## Design Review Commission Report

**Subject:** **718 NORTH ROXBURY DRIVE (PL1512989)**  
A request for an R-1 Design Review Permit to allow for the construction of a second story along with a façade remodel to an existing one-story single-family residence located in the Central Area of the City north of Santa Monica Boulevard. The Commission will also consider adoption of a Categorical Exemption, pursuant to the California Environmental Quality Act.

## 718 N. ROXBURY 2ND FLOOR ADDITION AND 1ST FLOOR REMODEL

### RESPONSES TO JUNE 3, 2015 DESIGN COMMISSION COMMENTS.

Project Name & Address <b>RESIDENCE FOR CAMERON YADIDI</b> 118 N. ROXBURY DRIVE VERLY HILLS, CA 90211	Drawing Title <b>EAST &amp; SOUTH ELEVATION</b>
Project No.	
Scale	
Date	
Designed	
Drawn	
Drawing No.	A2.016

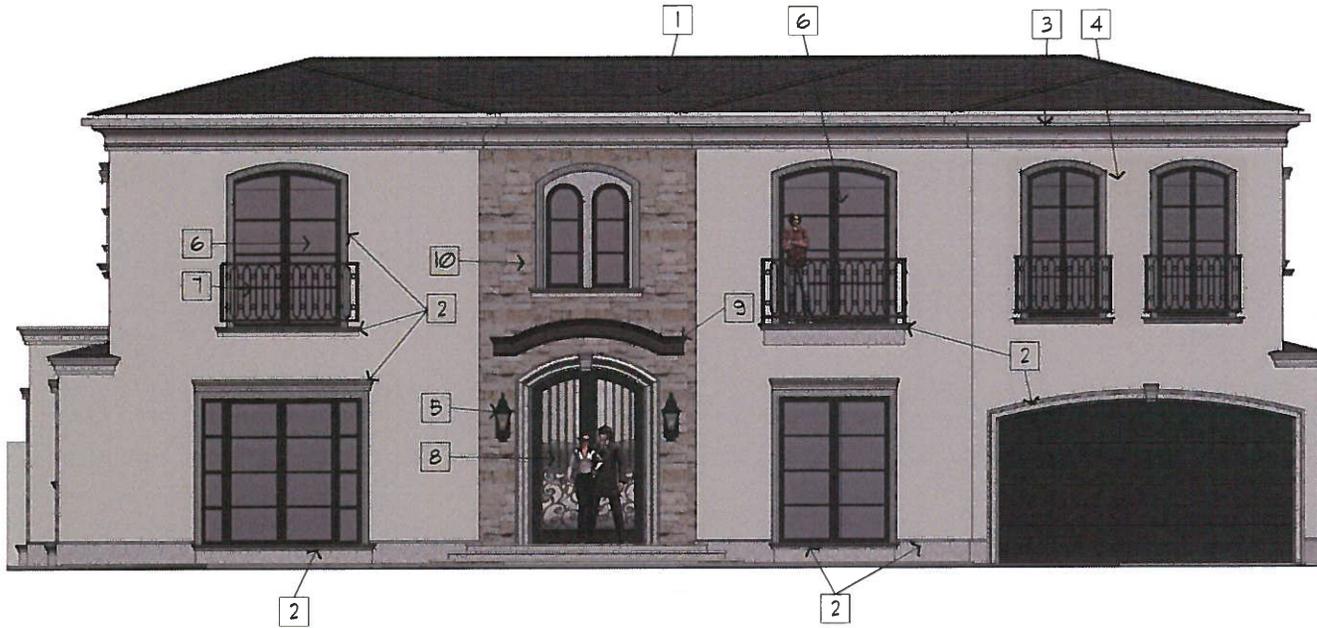
The proposed design exhibits improvement from the previous iteration; however, staff recommends approval of "Scheme C", which includes balconied doors at the second floor and a flat garage opening (as opposed to an arched opening). The balcony configuration creates a relationship with the other openings on the façade while drawing attention away from the front facing garage. The use of a flat garage top further helps to de-emphasize this element of the design.

1. The front façade elevation shall be consistent with “Scheme C” as submitted for review to the Design Review Commission.
